# Access Compliance Report

## Public Rights-of-Way

Intersection ID: 48998	Main Street: FALLON_FARM_RD	Cross Street: STEELECROFT_PY	Location: NW
ADA ID: 7E6A0A95692A	Ramp Type: BlendTrans1	Initial Pass/Fail: Fail	Overall Compliance: No
Severity Score: 1.25			
Codes/Mitigation Info/Possible Solution		Field Measurements/Component Compliance

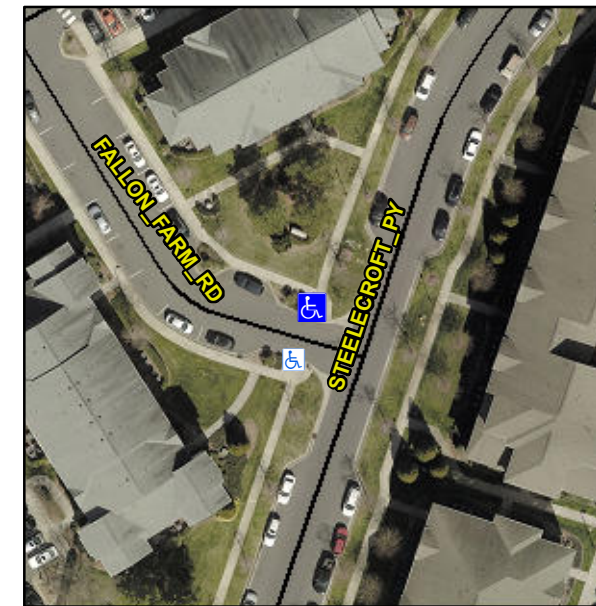
Compliance	Description	Data	Compliance	Description	Data
N/A	Ramp Length (in)	107.0	Yes	BlendTrans Slope (%)	2.7
Yes	Ramp Width (in)	48.5	No	BlendTrans XSlope (%)	2.1
N/A	Flare Type LT	N/A	N/A	Flare Type RT	N/A
N/A	Flare Slope LT (%)	N/A	N/A	Flare Slope RT (%)	N/A
N/A	Flare Traversable LT?	N/A	N/A	Flare Traversable RT?	N/A
N/A	Landing Length (in)	N/A	N/A	DWS Provided?	N/A
N/A	Landing Width (in)	N/A	N/A	DWS Contrast?	N/A
N/A	Landing Slope (%)	N/A	N/A	DWS Length (in)	N/A
N/A	Landing X Slope (%)	N/A	N/A	DWS Full Width?	N/A
N/A	Landing Curb? (Y/N)	N/A	N/A	DWS Offset (in)	N/A
N/A	Shared Landing?	N/A			
N/A	Gutter Ponding?	N/A	N/A	Gutter Slope (%)	N/A
N/A	Gutter Lip Ht (in)	N/A	N/A	Gutter X Slope (%)	N/A
N/A	Painted X Walk1?	No	N/A	Painted X Walk2?	N/A
	X Walk 1 Direction	To SW		X Walk 2 Direction	N/A
	X Walk 1 Width (in)	N/A		X Walk 2 Width (in)	N/A
	X Walk 1 Slope (%)	0.6		X Walk 2 Slope (%)	N/A
	X Walk 1 X Slope (%)	1.8		X Walk 2 X Slope (%)	N/A

**Remove & Replace Curb Ramp With Two New Directional Ramps or Equivalent.**

**R304.5.3**
